CALIFORNIA COASTAL COMMISSION

Re: Notice of Incomplete Coastal Development Permit Application 5-13-032 – Newport Banning Ranch

Comments on NBR CDP application submitted 10/30/14
Terry Welsh, Banning Ranch Conservancy
11-23-14

Figure 3. Location of fencing, educational signs and boardwalks needed for the protection of San Diego fairy shrimp habitat.

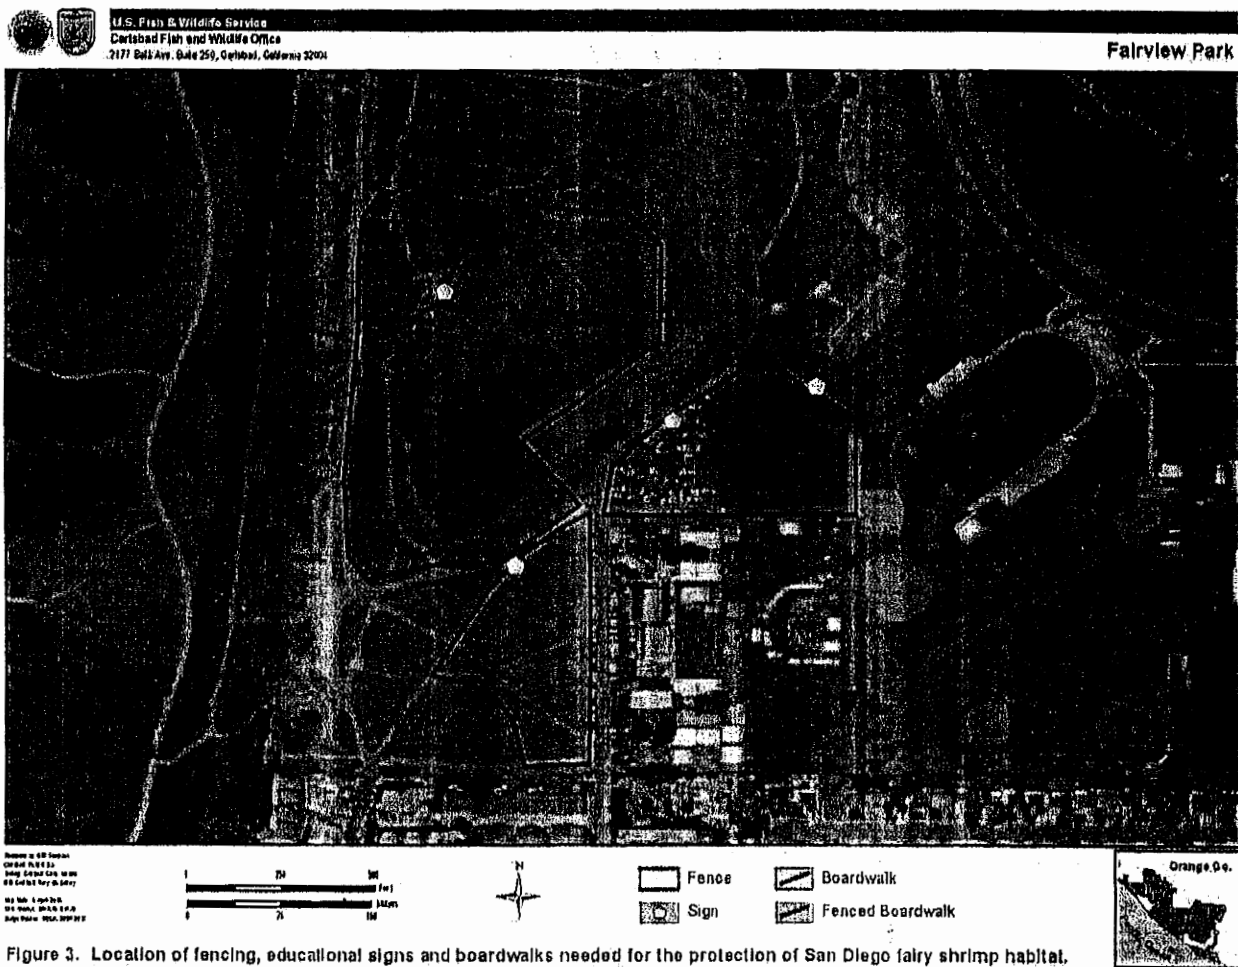
The applicant should provide a map of adequate watersheds with surrounding buffers, similar to that prepared recently by the USFWS, for every vernal pool/seasonal wetland on the Banning Ranch mesa (see attachment A).

6. In their HCCMP plan, the applicant has proposed preserving 7 of the 8 occupied vernal pools/seasonal wetlands, and "creating" additional occupied vernal pools/seasonal wetlands, in an approximately 8-acre area. The applicant has also proposed a monitoring method. While the applicant has provided their "expectations" of success, the applicant has provided no solid evidence that this proposal will result in the survival of the San Diego Fairy Shrimp on the Banning Ranch mesa, much less help in the recovery of this species from its endangered status.

Map 1 Recognized Environmental Conditions (RECs) / Potential Environmental Concern (PECs) Oil Field Abandonment and Remediation map provided by Dudek (2011 aerial source map and PEC data provided by Fuscoe Engineering).

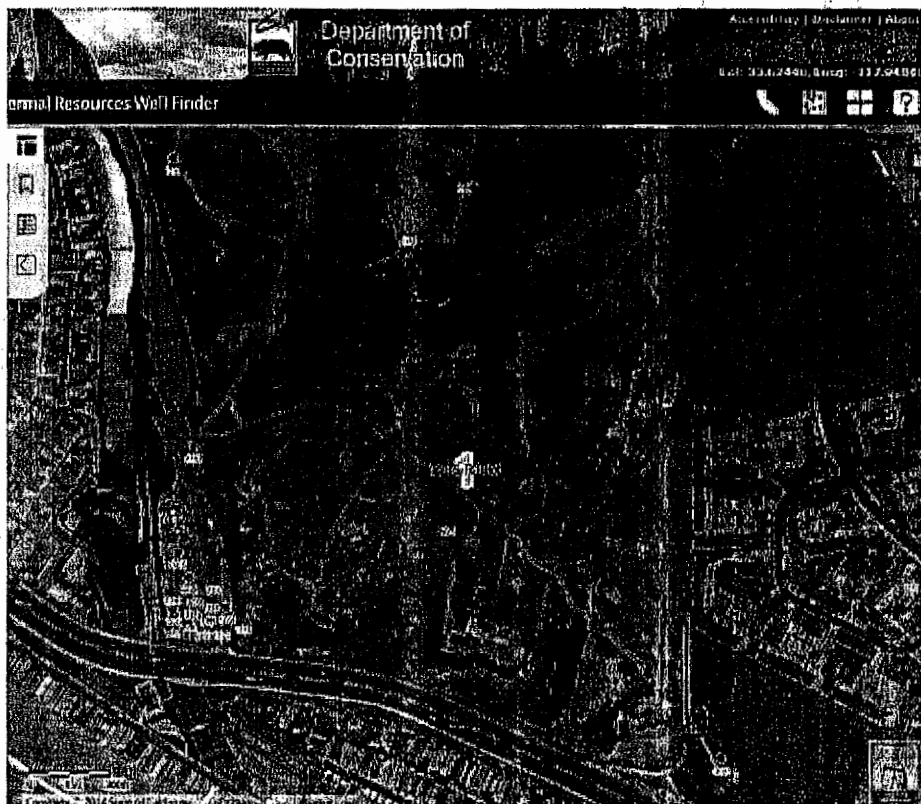
Additionally, the pipeline shown in this area extending from West Pacific Coast Highway to the PEC 22-Field Office, to PEC 23-Soil/Debris Stockpiles, and westward beyond does not describe what, if any use this pipeline serves. Has this been suggested to be an active pipeline?

There are NO active wells on the south mesa of Banning Ranch. After reviewing the proposed and active pipeline maps included along with the application for exemption filed by General Crude Oil Company July 27, 1973, the nearest mapping shows the pipeline could be a defunct well testing/oil gathering system.

Active wells on BR south mesa are highlighted in red.
